THE CORPORATION OF THE CITY OF COURTENAY

## BRIEFING NOTE

**To:** Council  
**From:** Chief Administrative Officer  
**Subject:** 5<sup>th</sup> Street Complete Streets – Project Update

**File No.:** 8520-01; 16009  
**Date:** May 9, 2017

**5th Street Complete Streets**  
 Overall - With Image

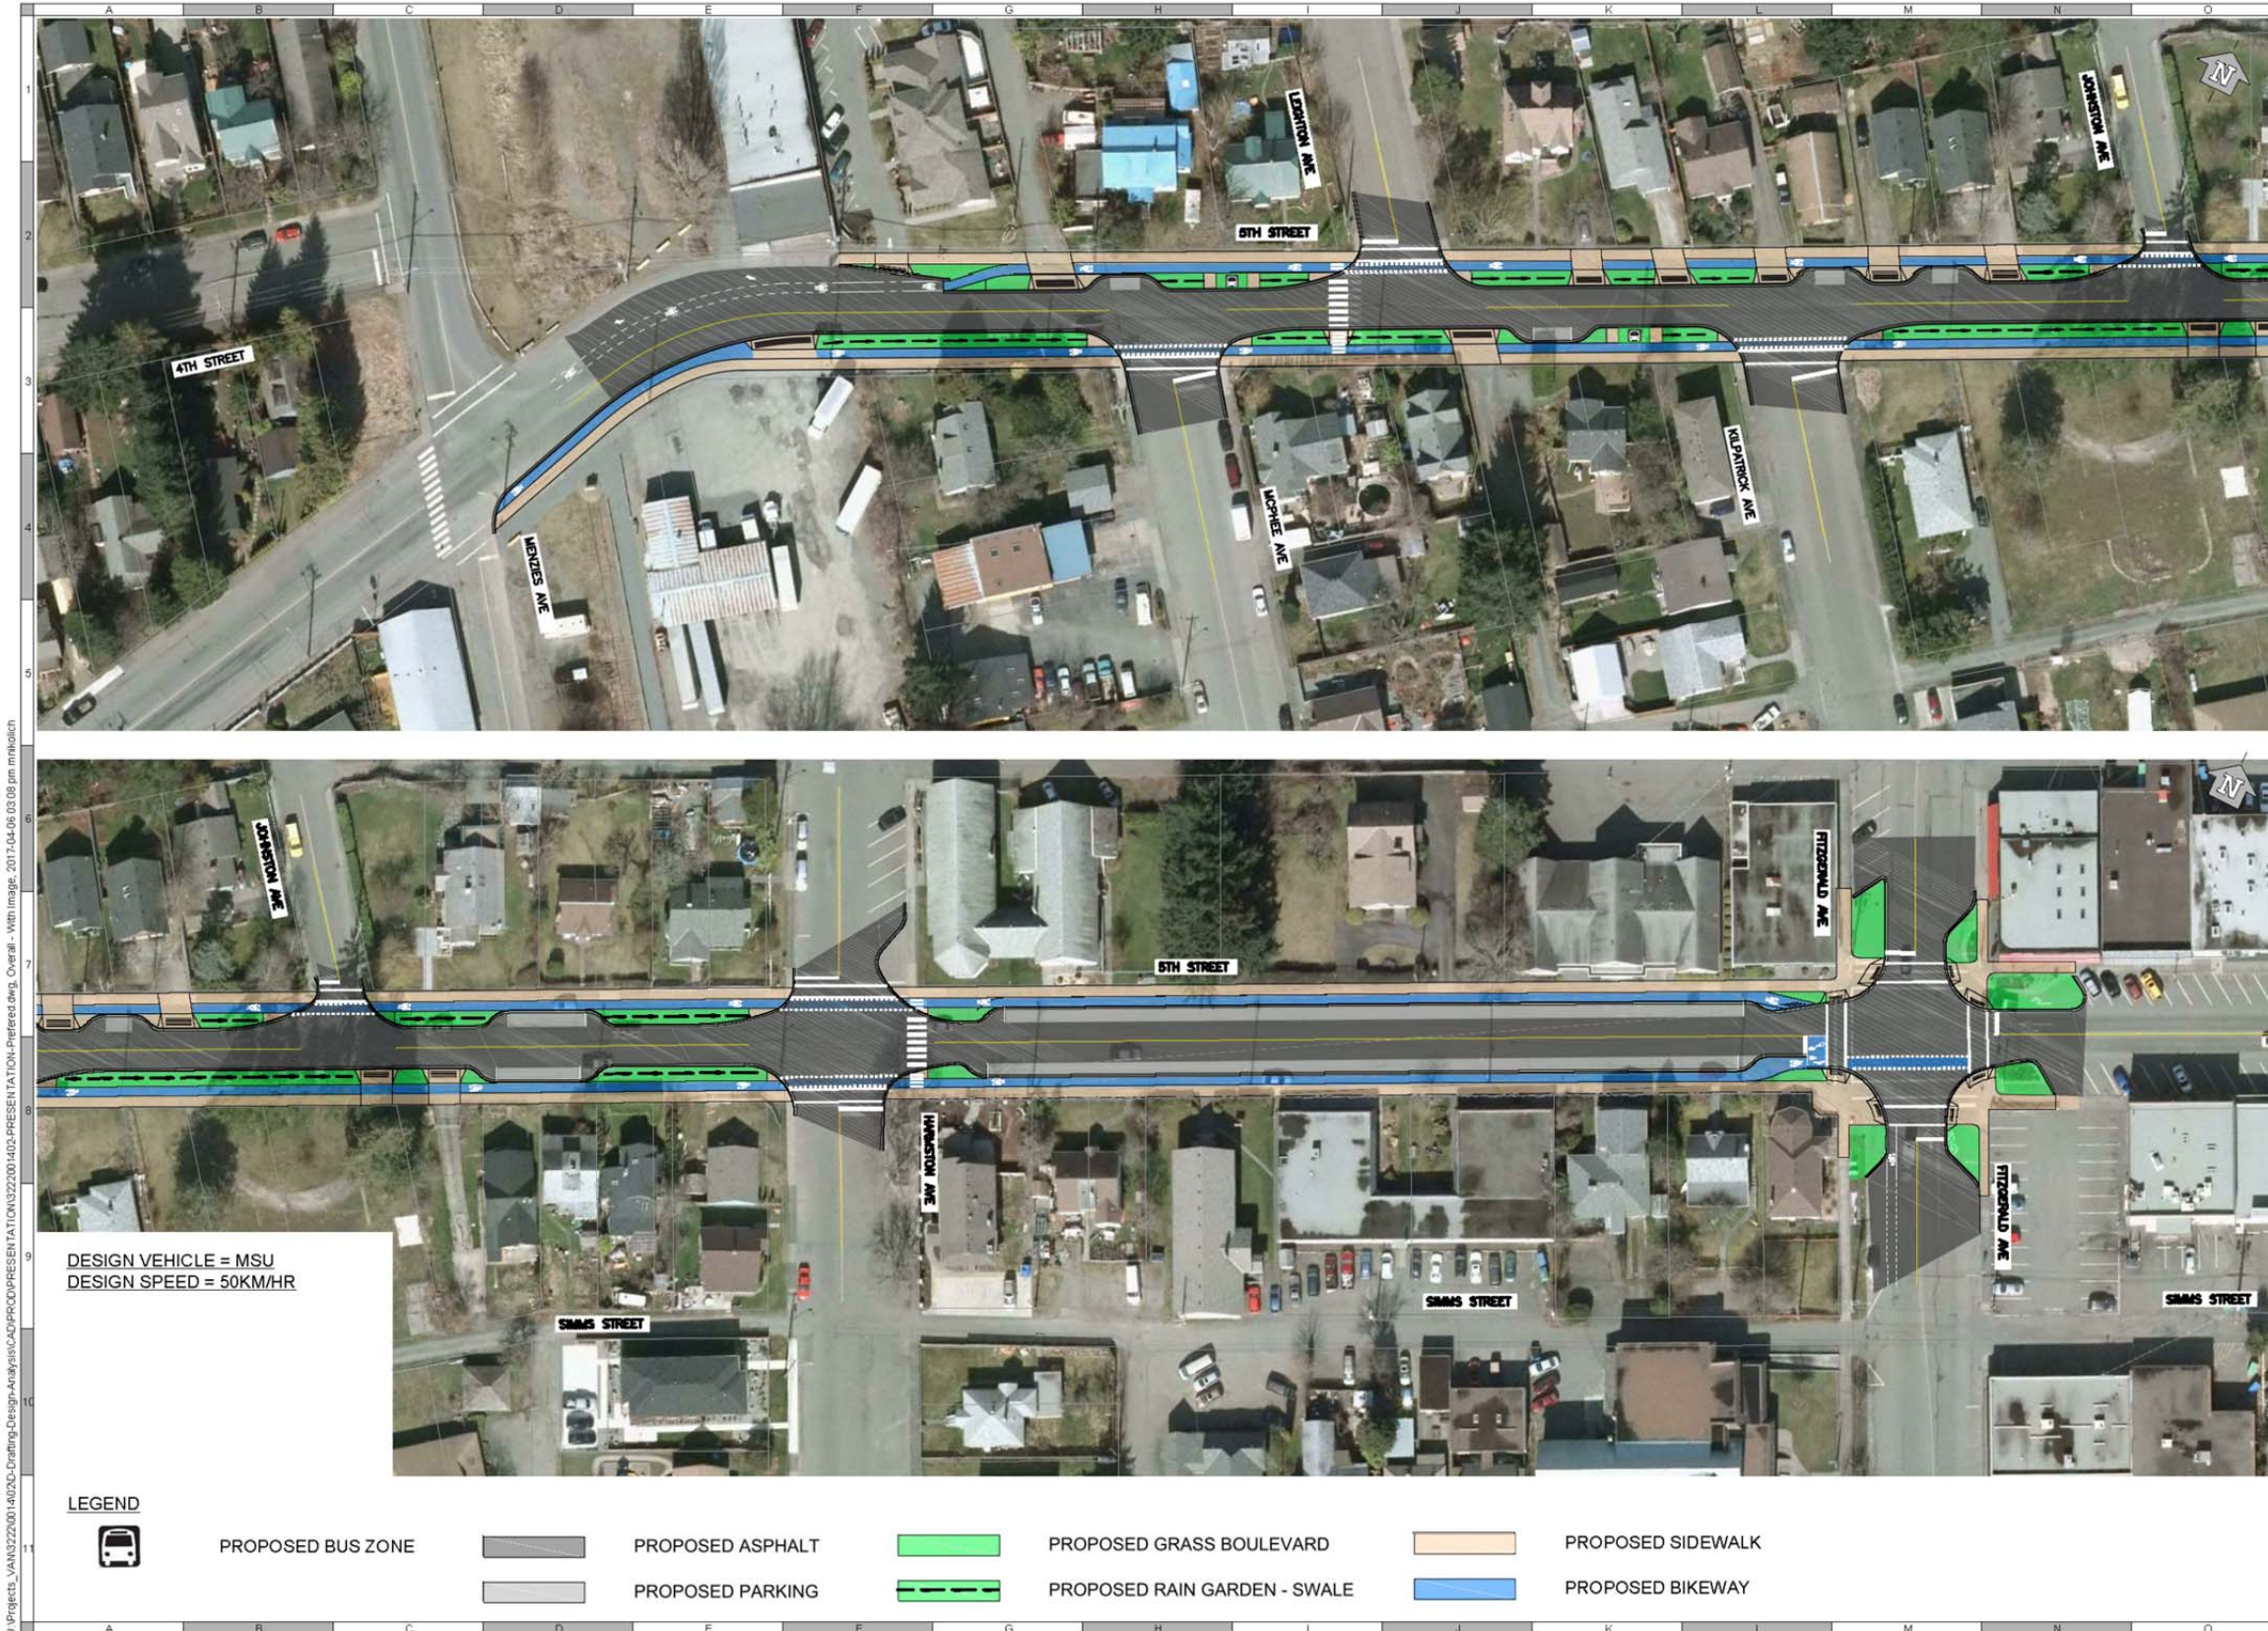
- Drainage considerations at 5<sup>th</sup> and Johnson – to be reviewed / addressed during Detailed Design.
- Relocation of the westbound transit stop further west in light of future bus exchange at Fitzgerald (comment from the Comox Valley Regional District) – transit stop relocated further west to Leighton Avenue.

- Relocation of pedestrian crosswalk at Leighton Avenue to the east side – not possible due to lane location, and relocation of transit stop.
- Additional parking spaces in front of residential properties – addressed in revised Functional Design where appropriate.

- The location of the bike lane between parked cars and sidewalk between Fitzgerald and Harmston is felt to be dangerous by some adjacent residents – no change was made to the Functional Design to reflect these comments as this was part of the cross-section approved by Council, identified throughout the community discussions as a trade-off to Option 4 (raised). Urban Systems will look for ways to improve safety concerns during detailed design (e.g. dooring from the passenger side), through potential signage, paint colour and bicycle markings, and educational opportunities.
